2024.00373.000

George Hotel Refurbishment (Planning & LBC) Response – Historic England (John William Street Wall). 25.06.25

Extract original (old) submission basement design/ 5797-01-01-02-003

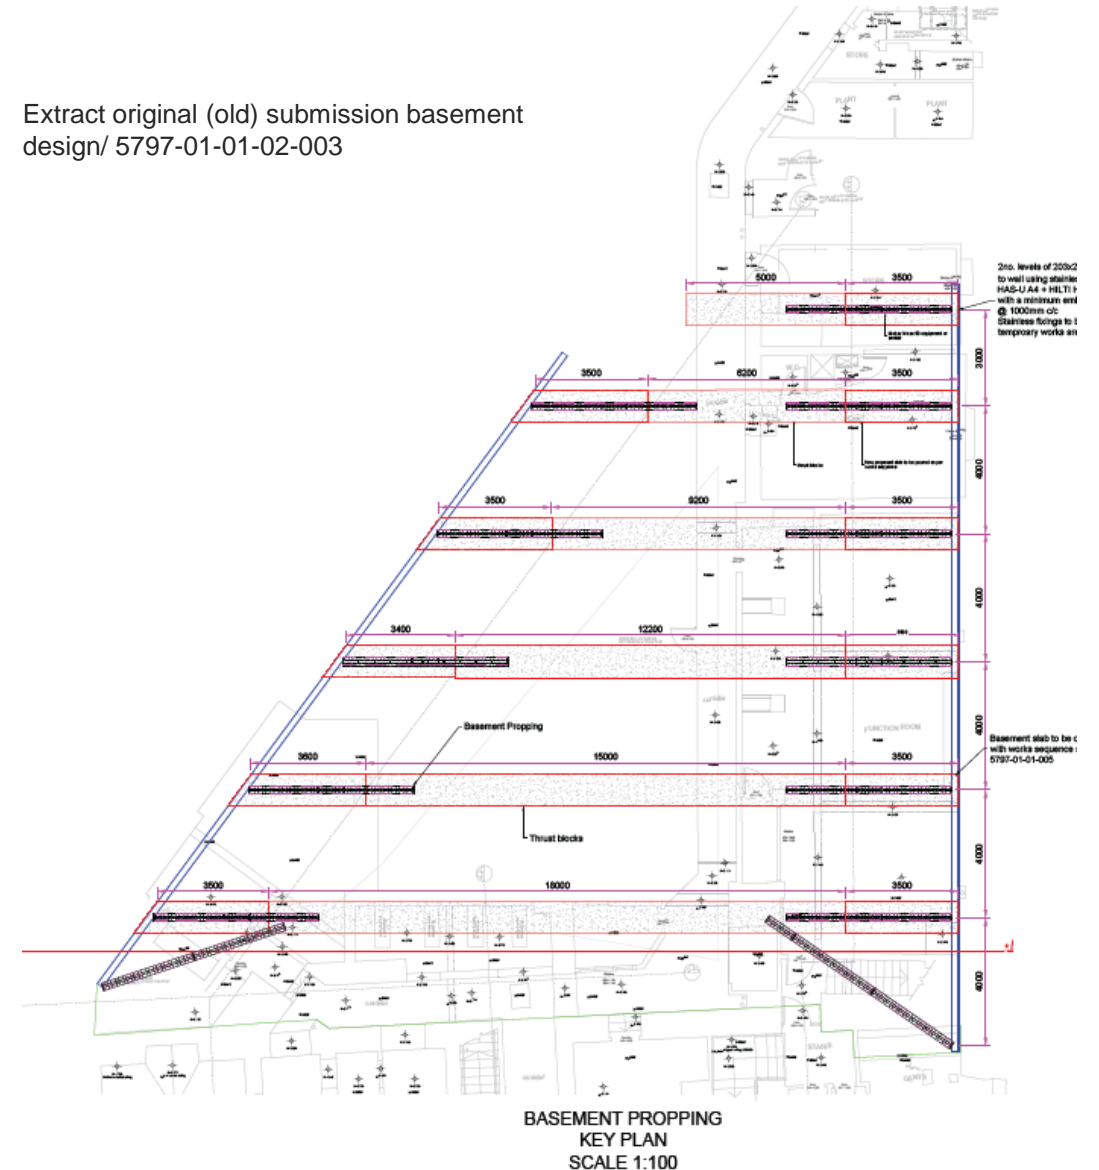
- Option 1 was recommended as best (Walers one side with mass towers & through bolt).
- Extensive thrust blocks would be required in basement (approx. 1m wide at 4m ctrs to entire footprint of Blocks A & B prior to mass demolition).
- Entire length of JWS wall will require underpinning with associated risks.
- Ground anchor works risk (undefined).
- Projection approx. 2m to roadway (would require agreement for say 2 year road narrowing and associated roadworks (islands and lights).

It is noted that this options report at that time had not developed to RIBA Stage 4 design level and as such required further testing in respect of deflection/ framework viability, general historic wall condition (internal) survey & ground condition evaluation to allow full validation of the practicability around retention.

It is also noted that the cost related to these works proposed were deemed to be of such a nature as to affect the cost viability of the scheme as a whole due to general issues around ground condition and further design viability and costing/ practicality assessment was required before this approach could be fully validated . This is common where planning is typically RIBA Stage 3b level and further design development in Stage 4 required before approach is finalised.

Extract of Ramboll Structural report ref: 1620012540-RAM-ZZ-XX-RP-S-001 George Hotel P01

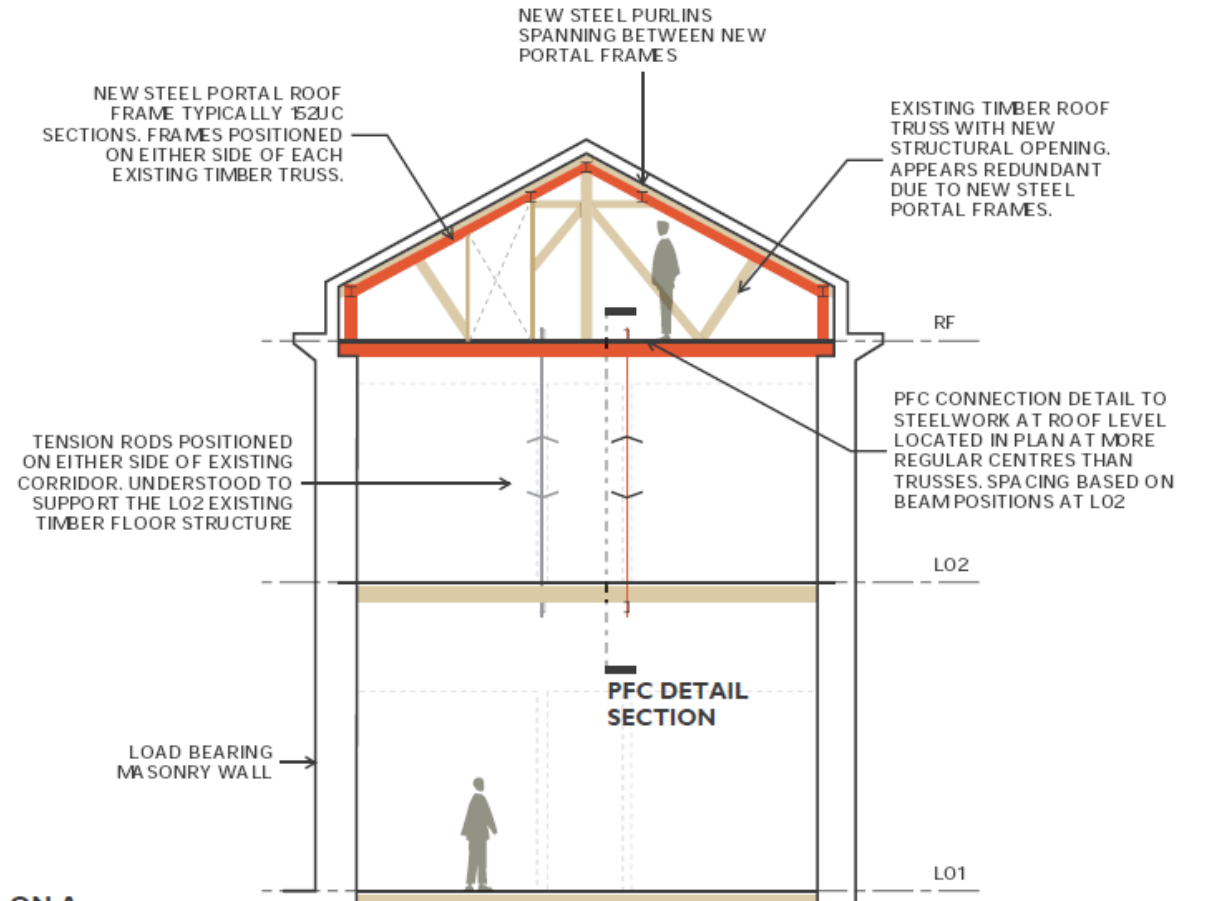
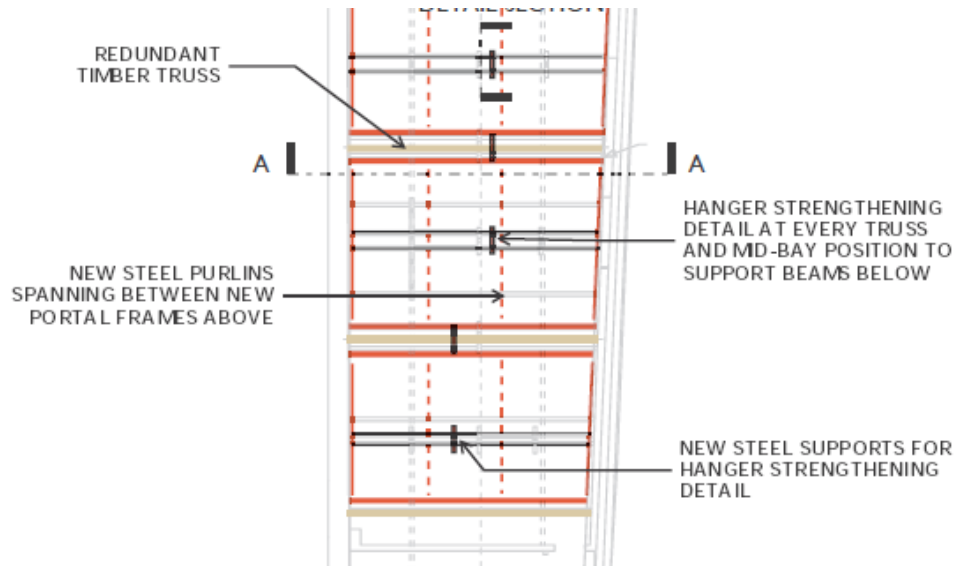
To clarify (and supplied by addendum by extract) it was found that the steelwork strengthening designs had not been performed with any form of Building Control approval and that indeed, this additional loading and its subsequent impact upon the structure below is an unknown factor (additional loading to walls already showing deflection).

This shows elements of the unlicensed alterations performed to upper levels of Block B in an attempt to address deflection and stabilisation concerns:

Extract of Ramboll Structural report ref: 1620012540-RAM-ZZ-XX-RP-S-001 George Hotel P01

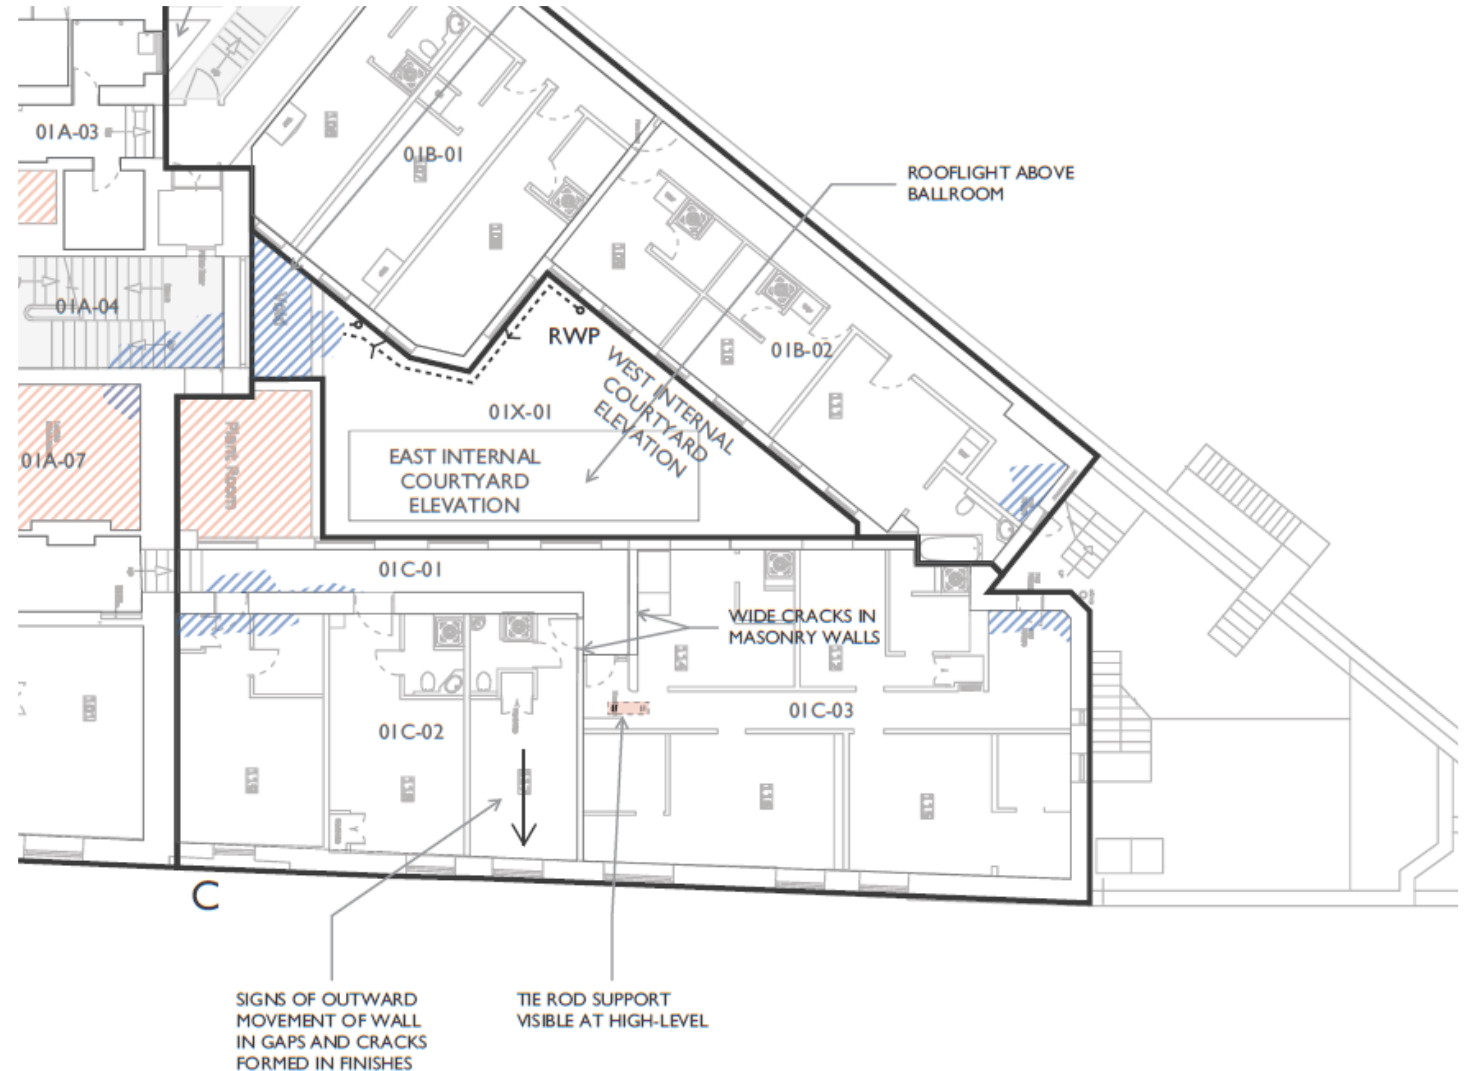
This shows initial record of movement generally at 1st floor level of concern raised in dialog in previous sheets.

Deflection extract – see appendix E

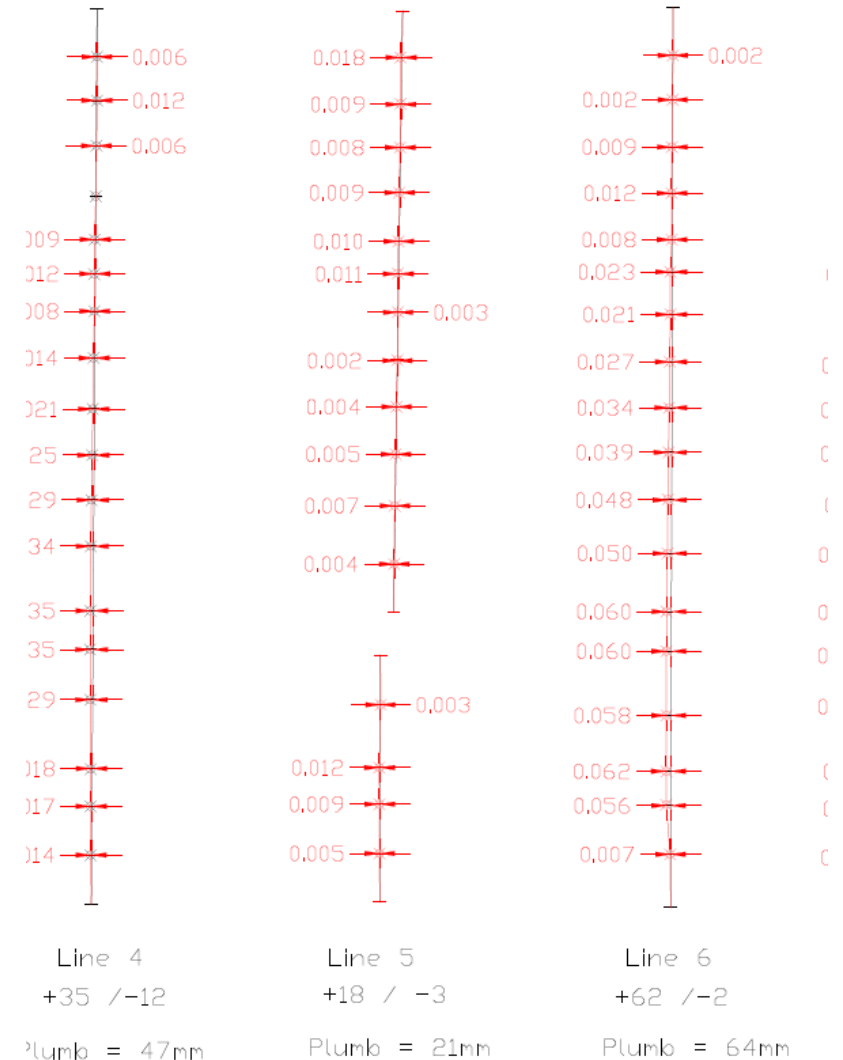
The outcome of these investigations was that there is indeed a deflection of 64mm primarily at the first floor level. This couples with the concerns raised in early investigations around the wall essentially bowing.

It is noted that the JWS wall recedes in thickness as it rises at each level and it is usually expected that bowing would occur at higher/ thinner sections of the wall. This bowing at essentially the thickest element of the wall indicates either slumping of washed fines (covered later in this report) or that upper sections through stones/ construction is better than that of the lower sections.

To clarify, the location of the bellow/ deflection is unusual in nature sufficient to justify not only the matters around the previously proposed underpinning but also that the factors of historic unlicensed loading, fines wash and general construction quality are all factors which are of a concern to the Principal Contractor and client in respect of risk and whether retention is a practicable or particularly correct option to be undertaken.

Section extract of further design proposals (MGF Structural Support) approx. dec 2023

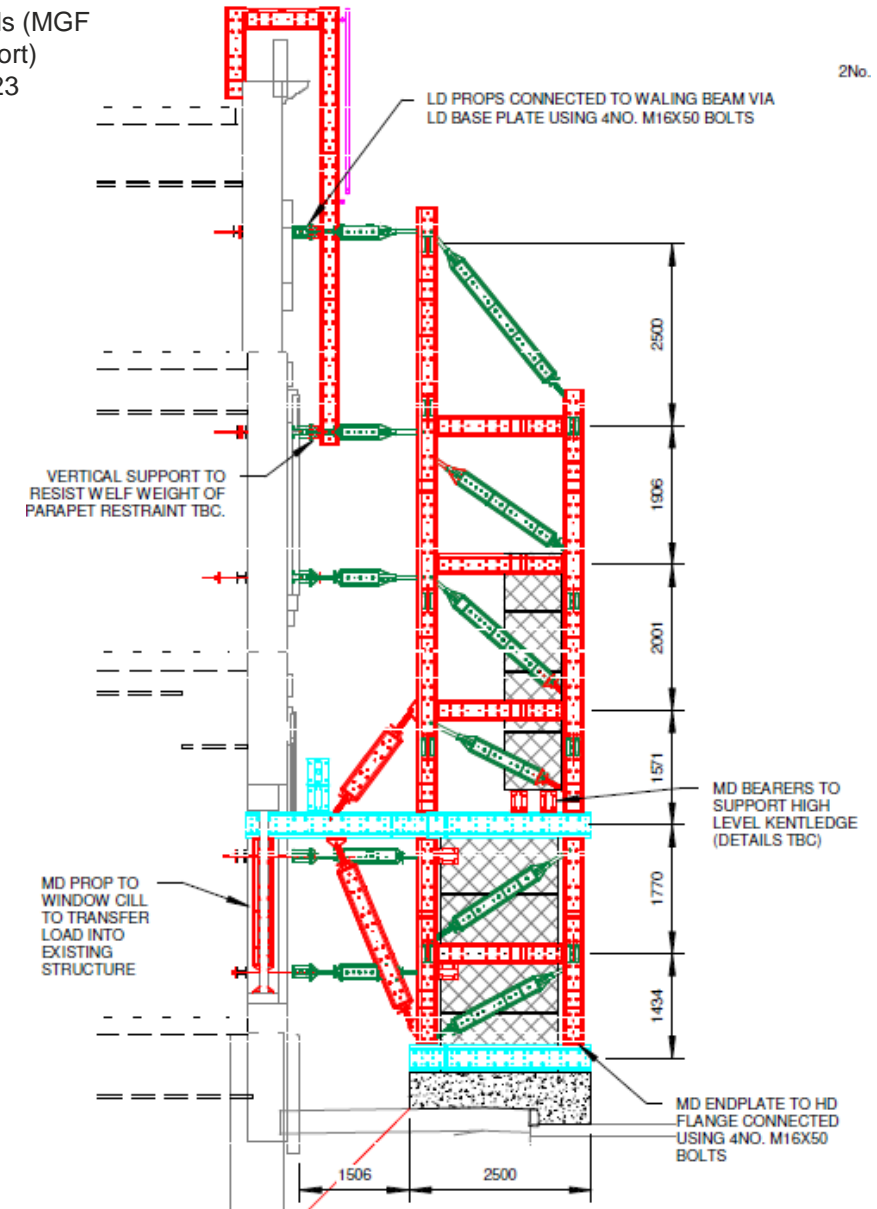
1. *Is the 25mm wind deflection risk acceptable and if not what could be done to lower this risk:*
 - Due to the lime mortar friability and unknown nature of wall quality and consistency it is not deemed acceptable - This is linked to item 2 below, the only practicable way would be to increase the frame size and fixing locations (mechanical) leading to increased projection into the JWS wall and increased material harm due to fixings.

2. *To prevent uplift a significant amount of ballast increase and increase in raft foundation would be required resulting in ground bearing pressures in excess of 85kN/m².*

1. The current ground bearing capacity has been assessed by the engineer to be much lower in the circa 40kN/m² due to ground CBR ratios understood at the site and more importantly the services which would be running directly under the retention structure (Gas, electric and water services on GPR Plan supplied). This would trigger the need for major services diversions which lie well outside the clients area of control or risk profile.

3. *Even putting aside the services risk, It is noted the Raft foundations required for such a retention structure would need to be within 150mm of the current wall.*

1. This prevents in entirety the option to stabilise the wall, the retention would need to be in place first to allow safe working and dig on the wall foundations to perform the underpinning of the JWS wall – this cannot be done from one side and in and of itself means in practice the retention is not feasible from a sequence of works perspective.

In summary, there is no iteration of retention design at this time that could demonstrate the principle of stabilisation could be practicably or safely performed by constructing operatives and that the risk of material harm further to the heritage fabric could not be sufficiently derisked.

Elevation extract of further design proposals (MGF Structural Support) approx. dec 2023

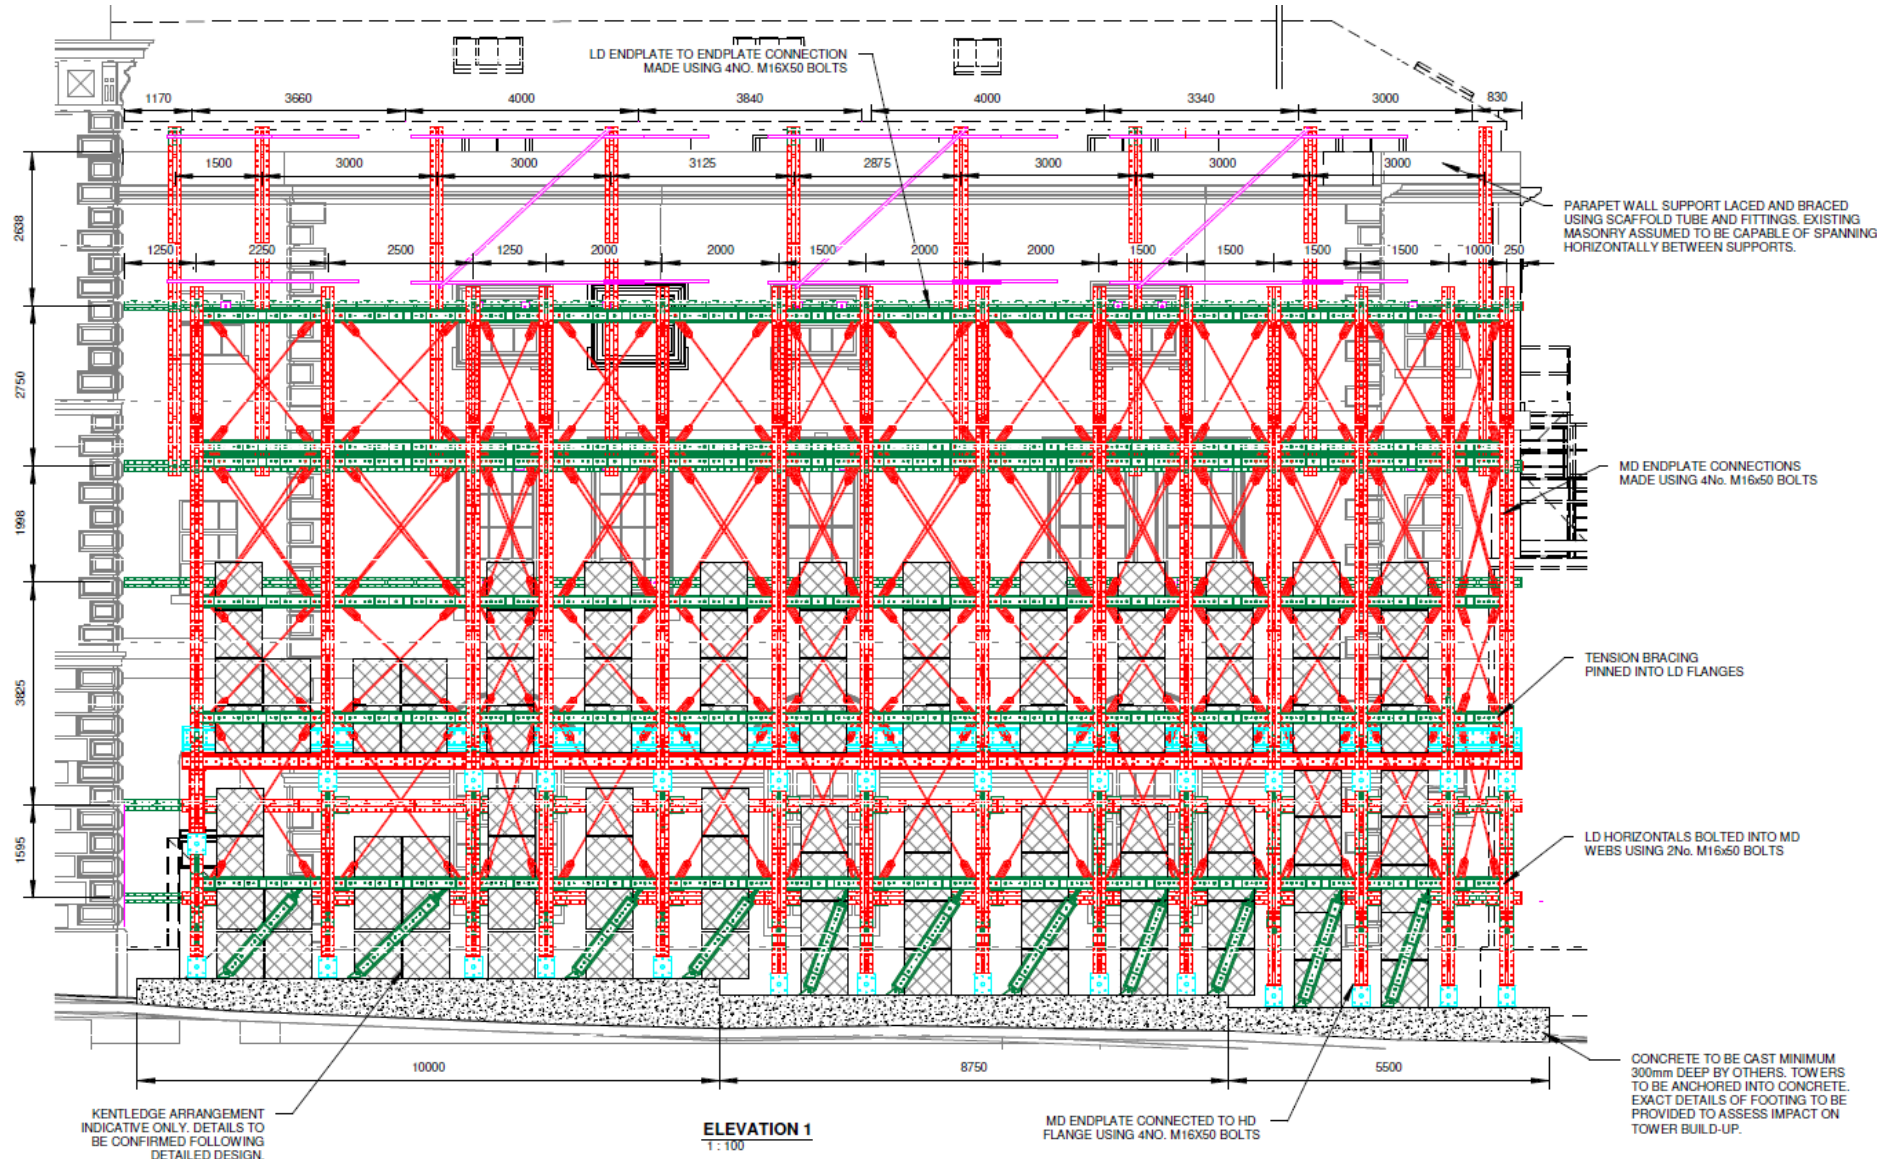
Note that the adjacent is predicated on surface retention and that subsequent investigations indicate through-bolting is likely to be required further exacerbating the risk of harm in respect of retention.

The reader is again reminded that the JWS wall does not sit in isolation and is inter-connected with the structure behind, the adapted and degraded iron beamwork over the kitchen end (North) and connected intrinsically to the Block A where uncontrolled movement could lead to unexpected consequential impact to associated fabric.
